ALERT SERVICE BULLETIN

EQUIPMENT AND FURNISHINGS - Emergency floatation system Inspection of the floatation balloon supply hoses

[ASB EC155 25A153](#)

**TITLE: EQUIPMENT/FURNISHINGS (ATA 25)
EMERGENCY FLOTATION SYSTEMS
INSPECTION OF FLOAT SUPPLY HOSES**

Figure 1

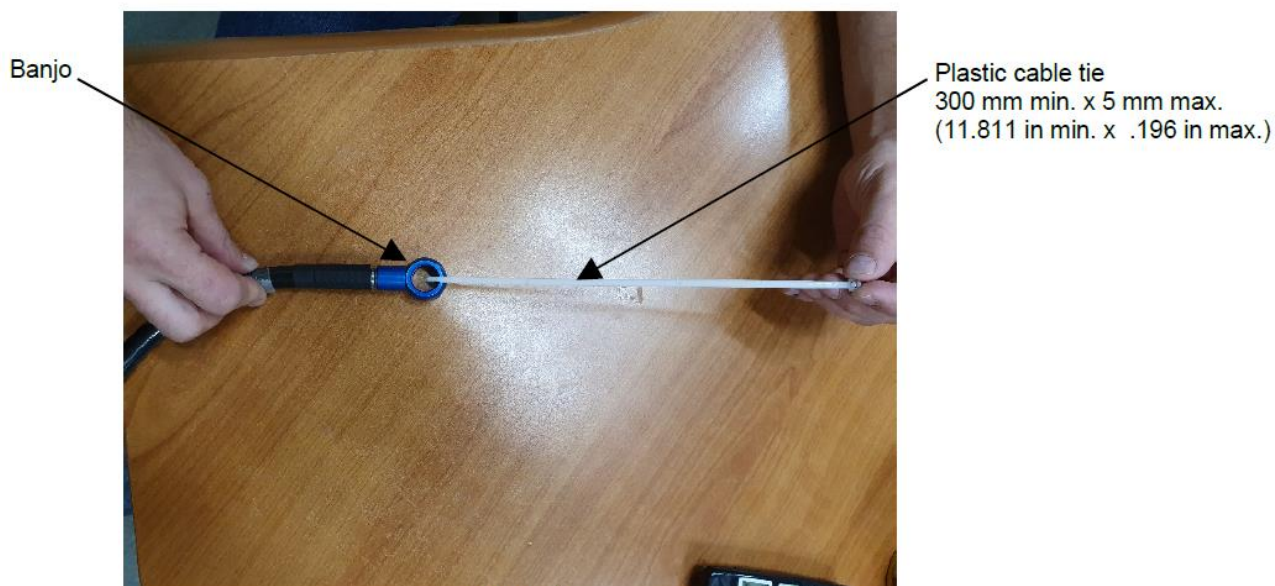
- (1) Inspection of single section hoses (in-service equipment, spare component and Part 21 material)
 - (a) Insert the end of plastic cable tie in the hole of outlet fitting (or banjo) (refer to Figure 1):
 - If the cable tie goes through the fitting (or banjo) freely up to a minimal length of 300 mm (11.811 in), the hose is fully operative (refer to Figure 2),
 - If a blockage occurs in the duct of the fitting (or banjo), the hose is blocked internally and must be replaced:
 - *If your material is Part 145 (in-service equipment and spare component) related:*
Please contact Safran Aerosystems Services to get a replacement part.

- (a) For each section of the hose to be inspected, insert the end of plastic cable tie in the hole(s) of related fitting (or banjo) (refer to Figure 1):
- If the cable tie goes through the fitting (or banjo) freely up to a minimal length of 300 mm (11.811 in), the hose is fully operative (refer to Figure 2),
 - If a blockage occurs in the duct of fitting (or banjo), the hose is blocked internally and must be replaced:
 - *If your material is Part 145 (in-service equipment and spare component) related:*
Please contact Safran Aerosystems Services to get a replacement part.

- *If your material is Part 21 related:*
Please contact Safran Aerosystems _ Floats & Rafts (F6101) to get a replacement part.
 - (b) After inspection, identify the hose inspected and found operative by applying a visible green "dot" on the base of the verified outlet fitting (or banjo) with a green Dykem mark & code pen ref. 84007 (or equivalent indelible green marking).

- (b) After inspection, identify the hose inspected and found operative by applying a visible green "dot" on the base of all the verified banjos with a green Dykem mark & code pen ref. 84007 (or equivalent indelible green marking).
- (c) Record the application of the service bulletin by writing down **SB 025-69-18** above the external identification marking of EFS.
- (d) Accordingly complete the log-card of the equipment when the hose is installed on EFS by writing the date and the reference of the Service Bulletin.
